**FOLLOW-UP FROM THE JUNE 28, 1994 OPERABLE UNIT 2
FEASIBILITY STUDY/PROPOSED PLAN WORKSHOP (RESPONSE TO
QUESTIONS ASKED AT WORKSHOP)**

**DOE-2036-94
DOE-FN PUBLIC
5
RESPONSES**

FOLLOW-UP FROM THE JUNE 28, 1994 OPERABLE UNIT 2 FEASIBILITY STUDY/PROPOSED PLAN WORKSHOP

**OPERABLE UNIT 2
TYPICAL DETAIL
COMPOSITE CAP AND LINER**

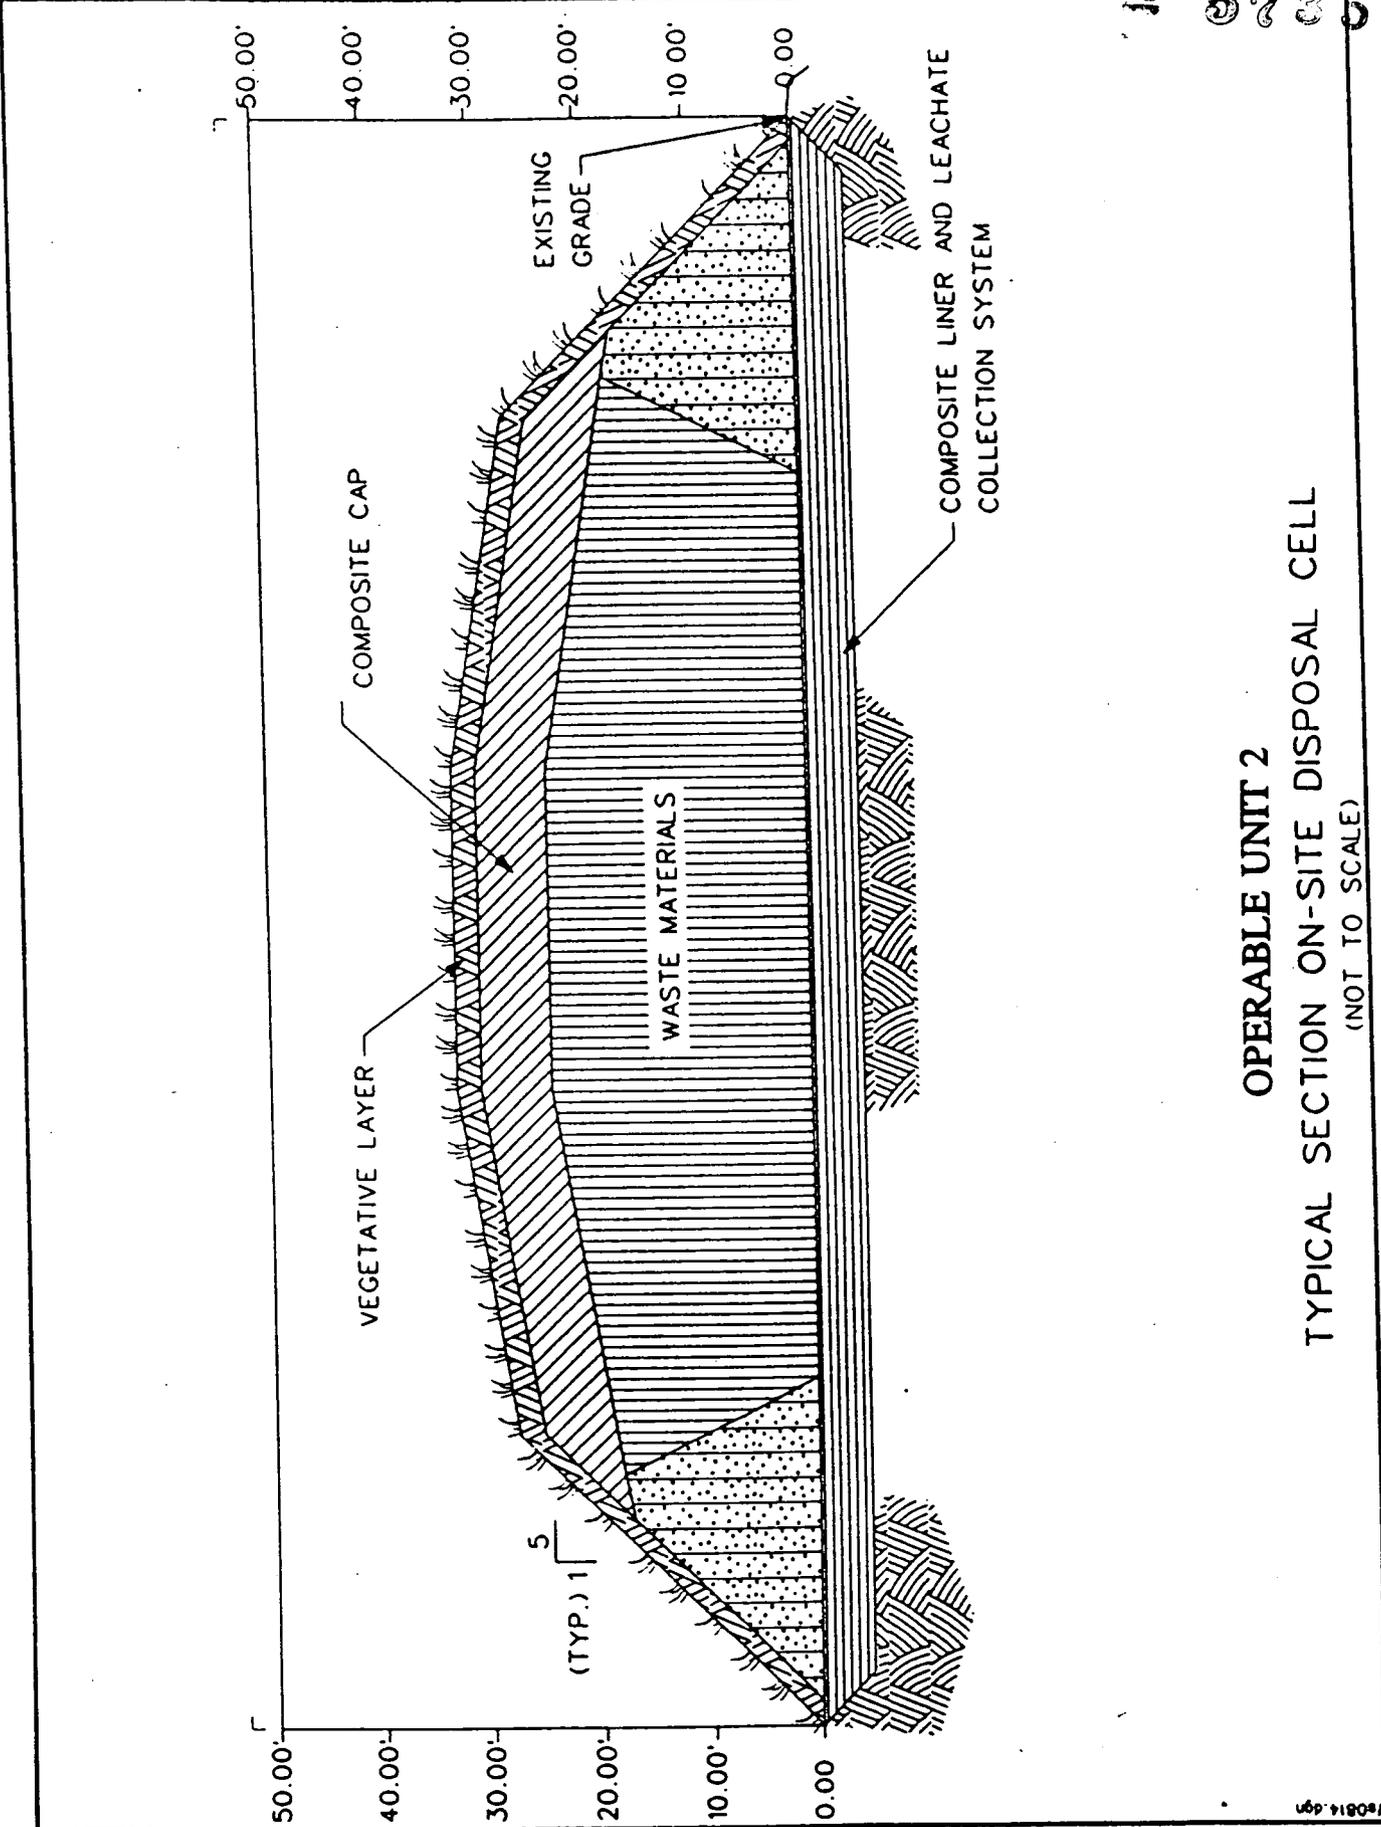
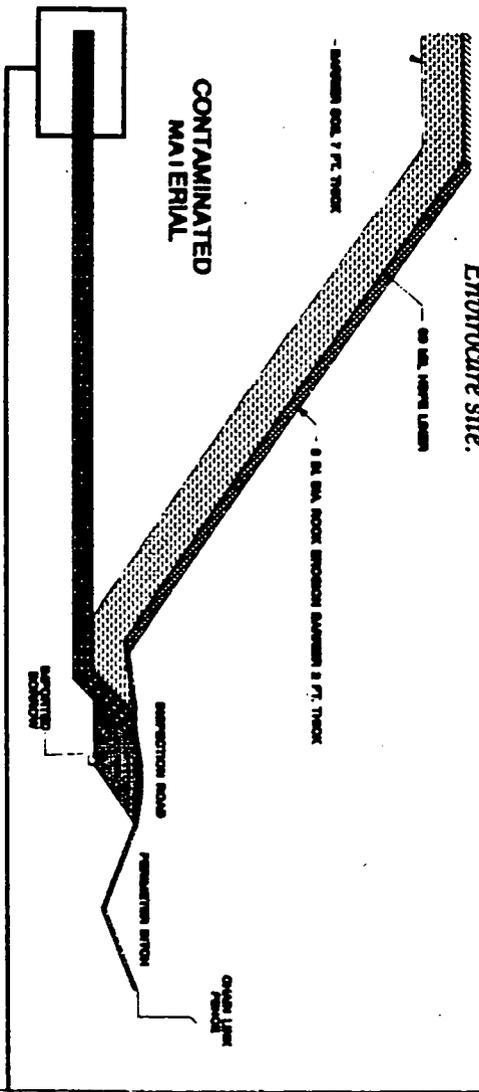
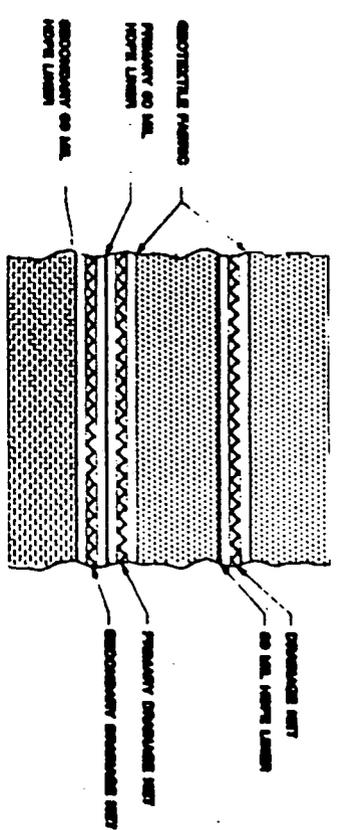
2. **Are Envirocare and the Operable Unit 2 proposed disposal cell similar?**

As the attached figures illustrate, both Envirocare and Operable Unit 2's proposed on-site disposal facility are similar in the protection that they provide. Operable Unit 2 has proposed a cap system an additional drainage layer while Envirocare includes an additional drainage system in the bottom liner. It is important to remember that Envirocare's facility has been designed to accept not only low-level radioactive waste but also mixed waste (waste with a radioactive and hazardous component). The Operable Unit 2 disposal cell has been designed to accept low-level radioactive waste only.

OPERABLE UNIT 2
TYPICAL SECTION ON-SITE DISPOSAL CELL
 (NOT TO SCALE)

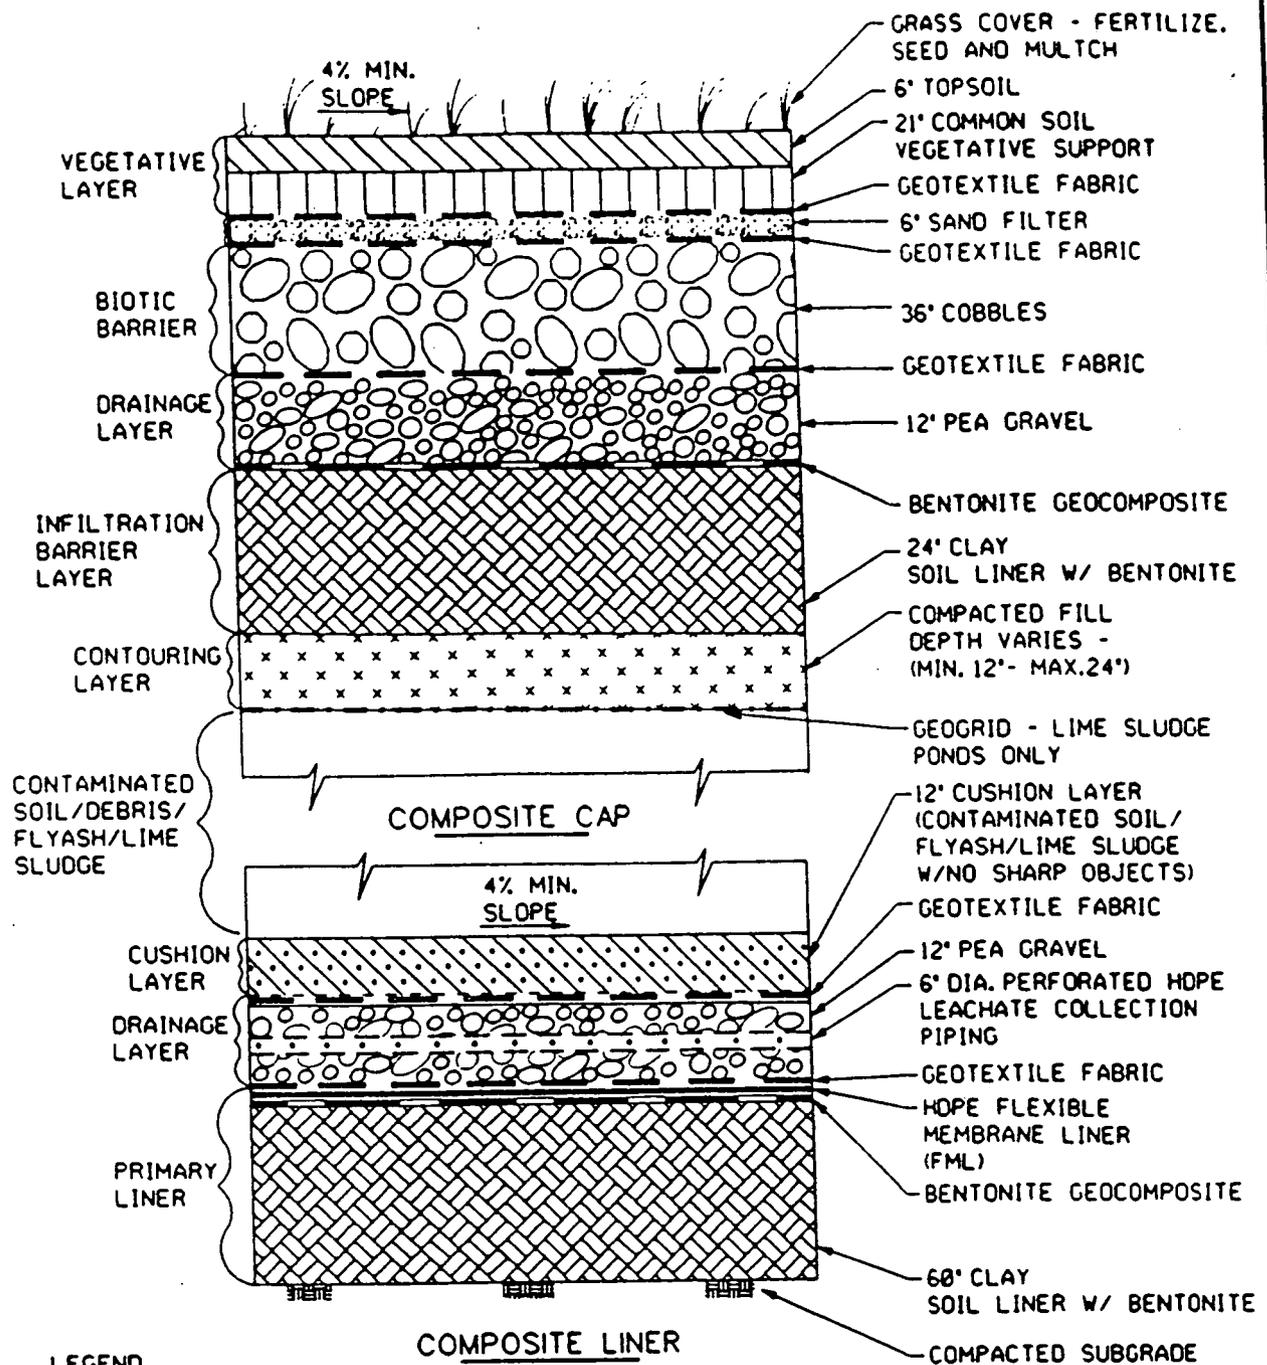
1. **The public requested a copy of the cross-section of the disposal cell.**

See attached figure from the Operable Unit 2 Proposed Plan of April 1994.
